**339-377 FOREST ROAD  
BEXLEY**

**Statement of Environmental Effects**

**Proposed New Child Care Facility**

Design as submitted – Section 4

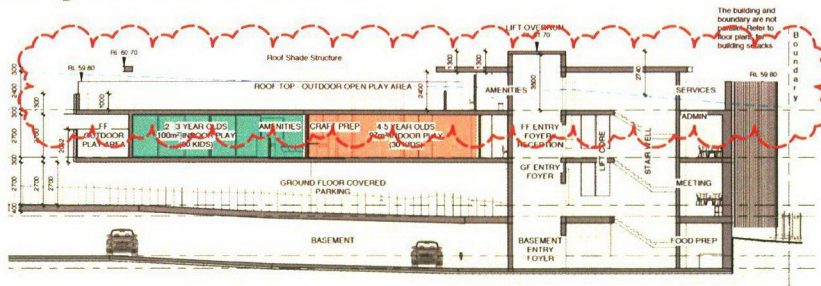
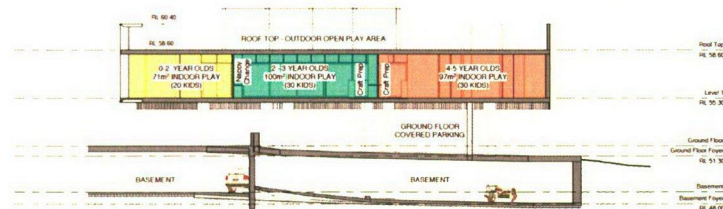
- **Reduction in Childcare Building Height:** The building has been substantially redesigned to reduce the overall maximum height, particularly at the Forest Rd and Bayview St intersection. Notably the height has been reduced in the following areas:
  - at the lift overrun **by 0.7m** from 11.67m (RL62.4) to 10.97m (RL61.7).
  - at the south-western corner (Forest Rd and Bayview St intersection) **by 2.1m** from 11.9m (RL61.9) to 9.8m (RL59.8).
  - at the roof form over the stairs and amenities area **by 1.2m**. This area has been set in from the edge of the building about 1m.

Design as submitted – Roof top plan – north elevation

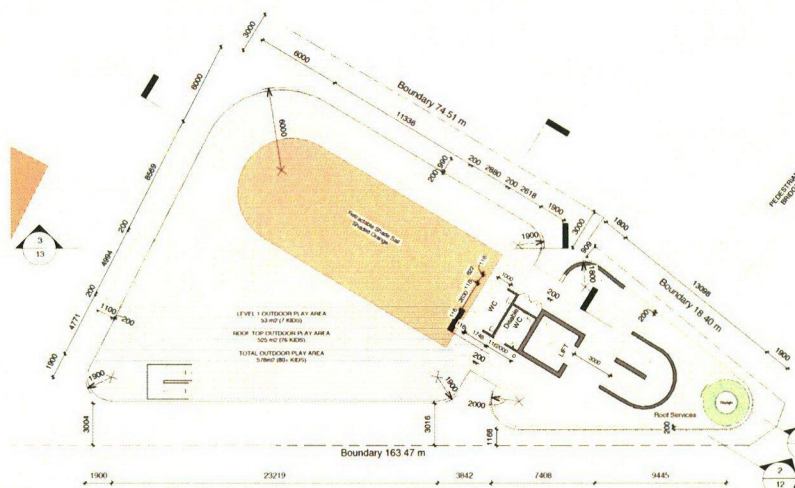
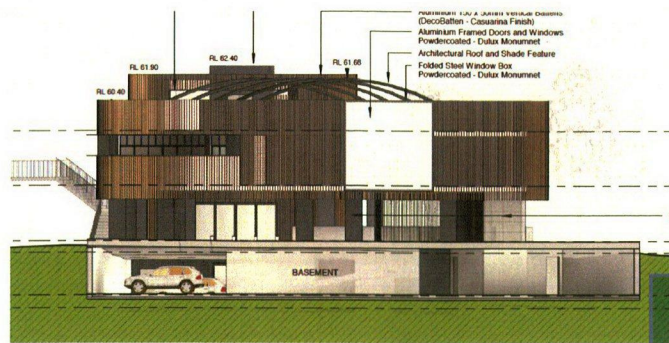
- **Changes to the rooftop feature/shade structure:** The architectural roof and shade feature has been removed and replaced with retractable roof shade structure within a steel frame as shown in the screenshots below.

Design as submitted – site plan

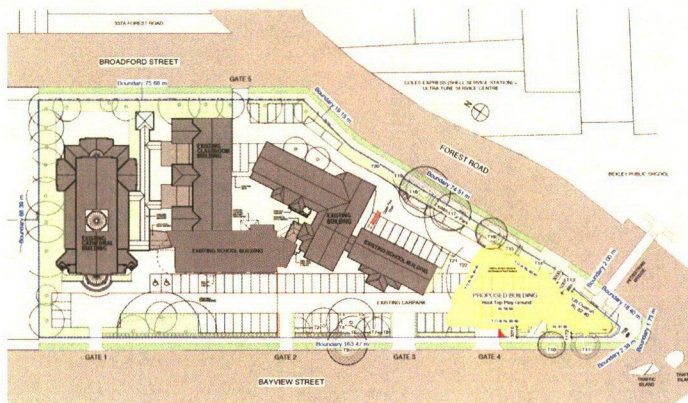
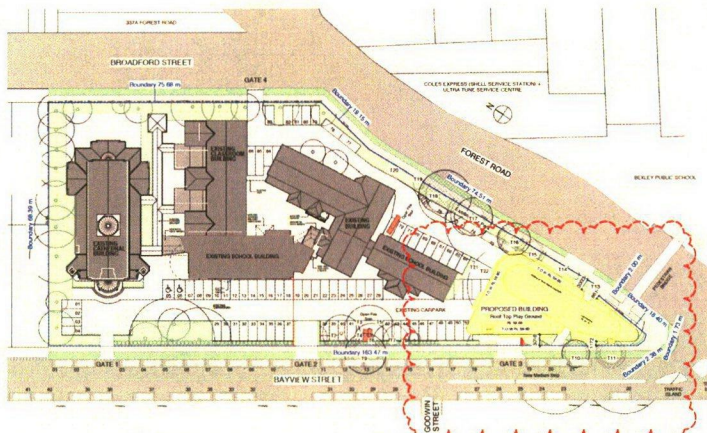
- Reduction in Childcare GFA:** The existing GFA has been clarified across the whole site based on calculations made from approved plans. In this regard it is noted that existing buildings are 3,175 sqm in area. The Gross Floor Area (GFA) of the proposed Childcare Centre has been reduced by 41sq.m from 869sq.m to 828 sqm. Based on a site area of 8,388sq.m this results in a reduction of total FSR over the whole site from 0.48:1 to 0.477:1.
- Changes to site access arrangements:** As noted in the addendum Traffic and Parking Assessment prepared by Hermanote Consultants: *"The proposed access driveway originally located opposite Godwin Street has been deleted. The revised plans provide only one additional access driveway, labelled as 'Gate 2' on the revised site plan providing two-way access and is located away from Godwin Street."*

Design as submitted – ground floor plan

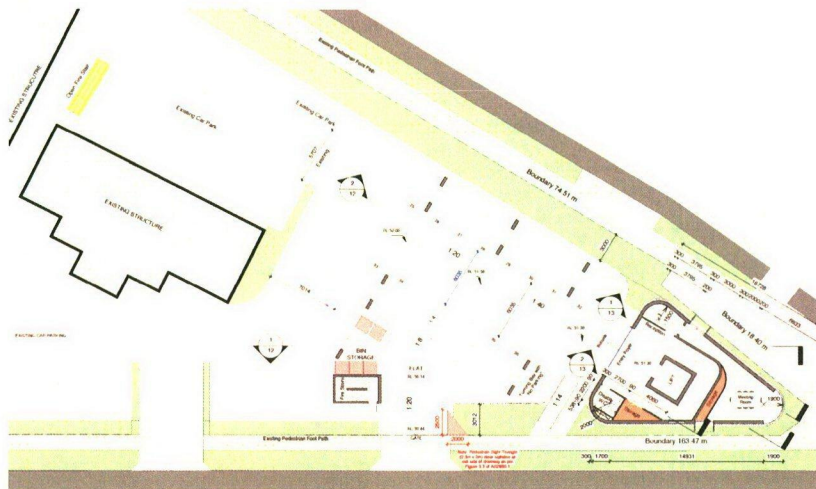
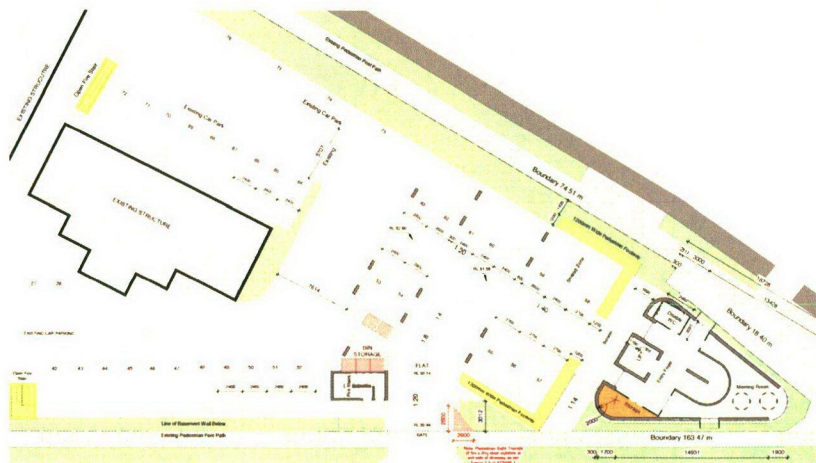
- Reconfiguration of parking arrangements:** As noted in the addendum Traffic and Parking Assessment prepared by Hermanote Consultants: *"The revised plans provide a total of 112 off-street car parking spaces, including 100 car spaces as per the previous development consent for the existing church and school and 12 new additional car spaces for the proposed childcare centre. Therefore, the approved 100 car spaces for the previous consent for the church and school will be fully retained. The proposed additional 12 car parking spaces for the childcare centre have been relocated to the ground level and are no longer in the basement."* Refer plan extracts below.

Figure 1: Sheet 20 Extract

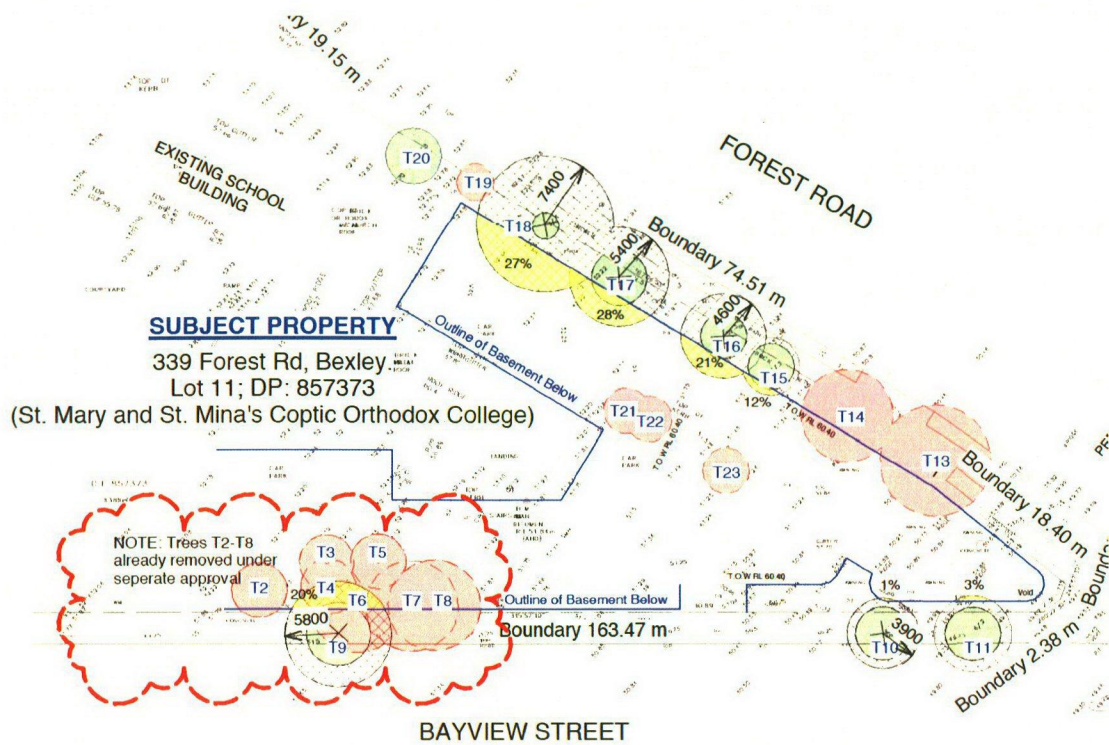
*"Looking at sheet 20, why would Gate 2 be closed 4pm to 6pm? Wouldn't this coincide with afternoon CCC pick up?"*

Gate 2 will be opened on Monday to Friday from 7am to 10pm and will be patrolled during "school zone" hours. Sheet 20 has been amended accordingly, (as also shown in the plan extract below):

Figure 2: Sheet 17 Extract

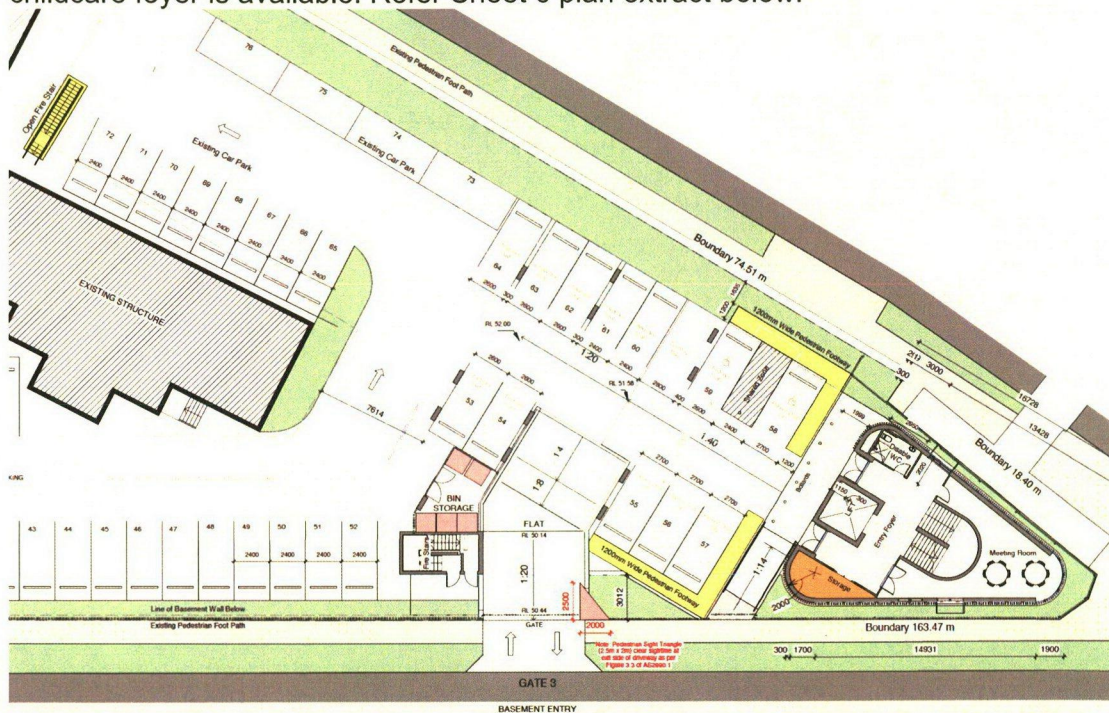
*"Based on the latest aerials looks as though some of the tree removal has taken place (T2 – T8 removed?). As a result, Tree Management Plan sheet 17 needs updating".*

It is correct that some trees have been removed. This was done under a separate approval and accordingly sheet 17 of the architectural set has been updated to reflect this (refer plan extract on the following page).
